Access Report

**Mixed Use Development**  
13-17 Oxford St & 2 Verona St  
PADDINGTON NSW 2021

For: 17 Oxford St Pty Ltd  
c/- Aspire Property Consulting  
Ref: PAA\_25076

Development application documentation, for the Mixed Use development located at 13-17 Oxford St & 2 Verona St Paddington, has been reviewed against current accessibility legislation.

Figure 2 (b) | ground level plan – terraces

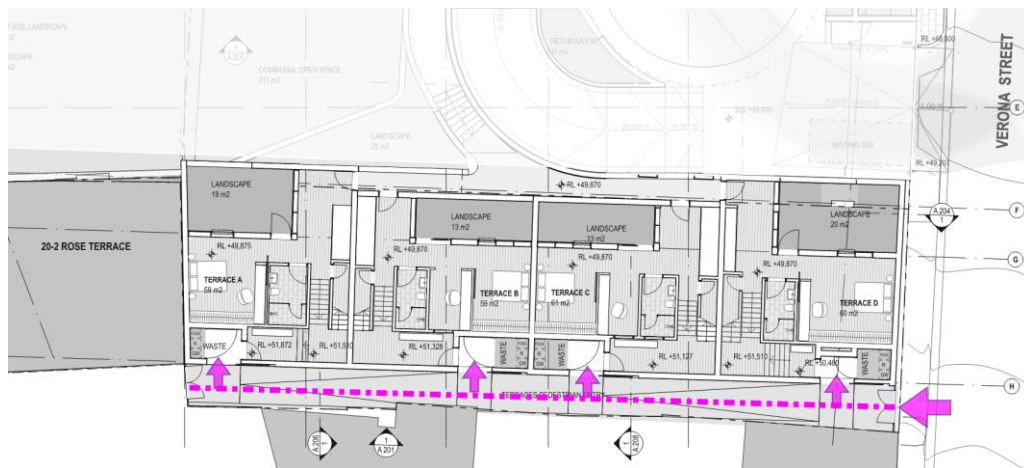
Footpaths that form the approach to the individual terrace entrances provide minimum widths and AS1428.1 compliant gradients.

Figure 3 | ground level plan

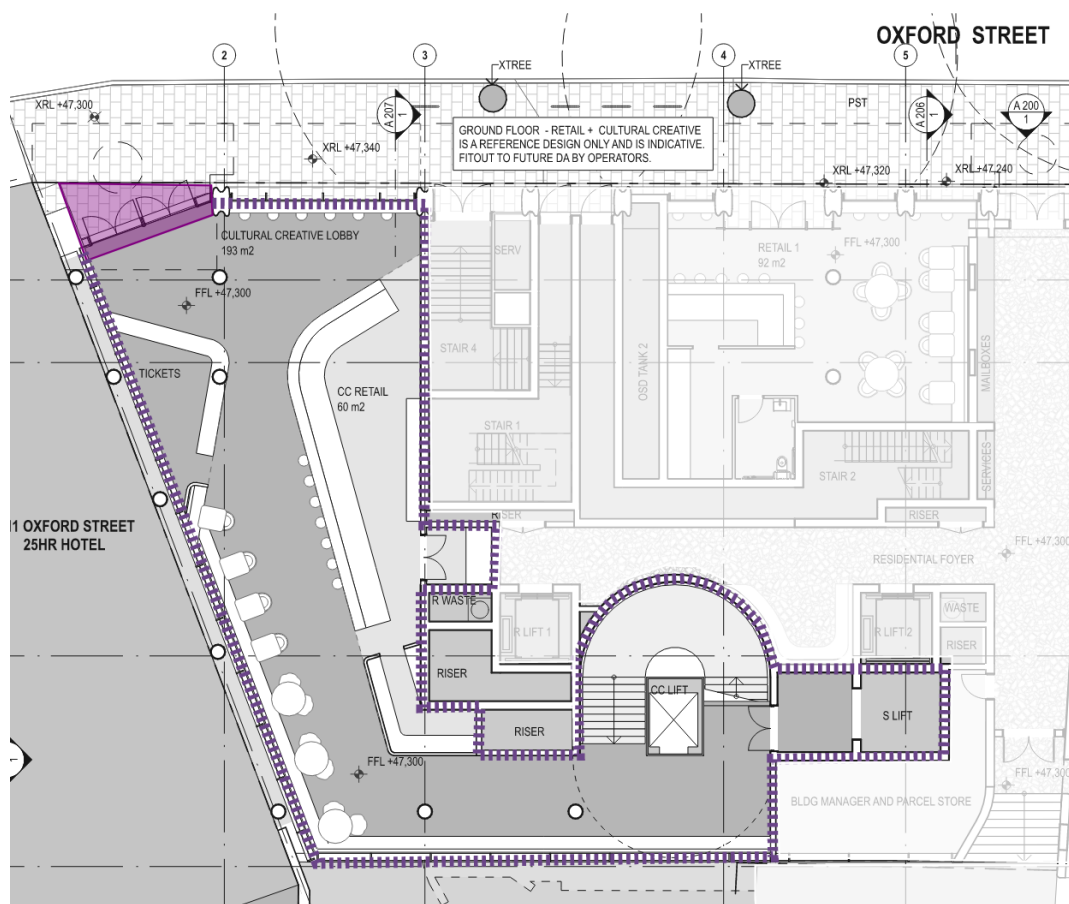
Base build works are highlighted purple on the plans below. The ground level fit out works are contained within the purple dashed line. The majority of Basement Level 3 will be subject to a separate building approval.

Double hinged doorways provide entry to the ground level lift lobby of the Cultural Creative and offer compliant circulation areas and a level threshold hold is achievable.

Figure 5 | Ground level retail spaces plan

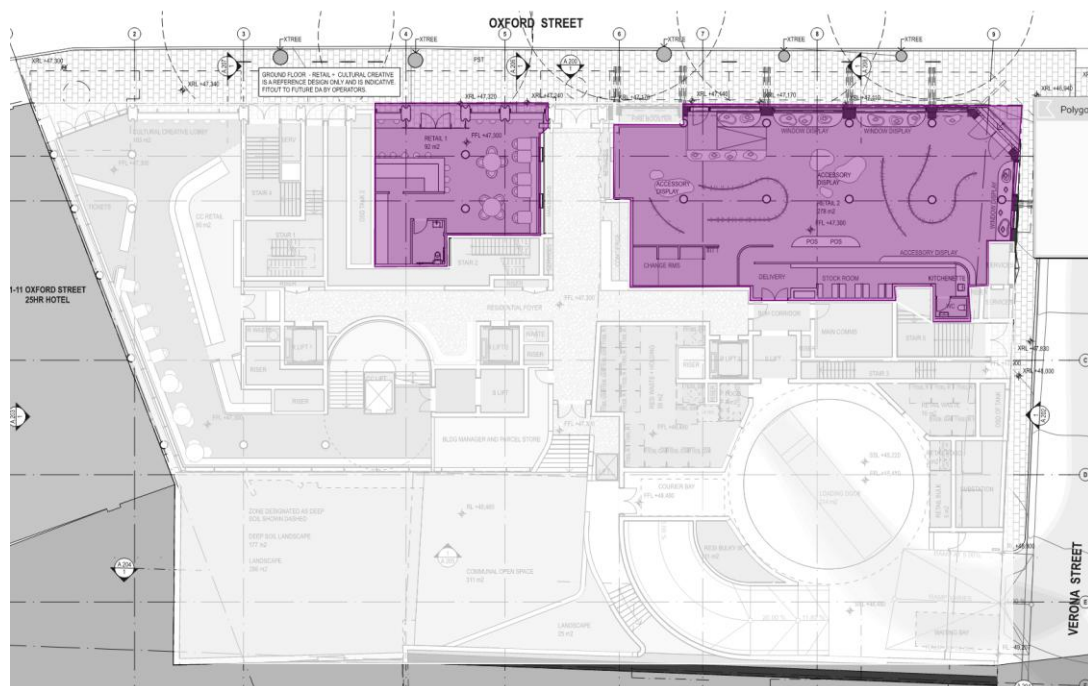
Retail spaces are highlighted purple on the ground level plans below.

Double hinged doorways provide entry to Retail space 1.
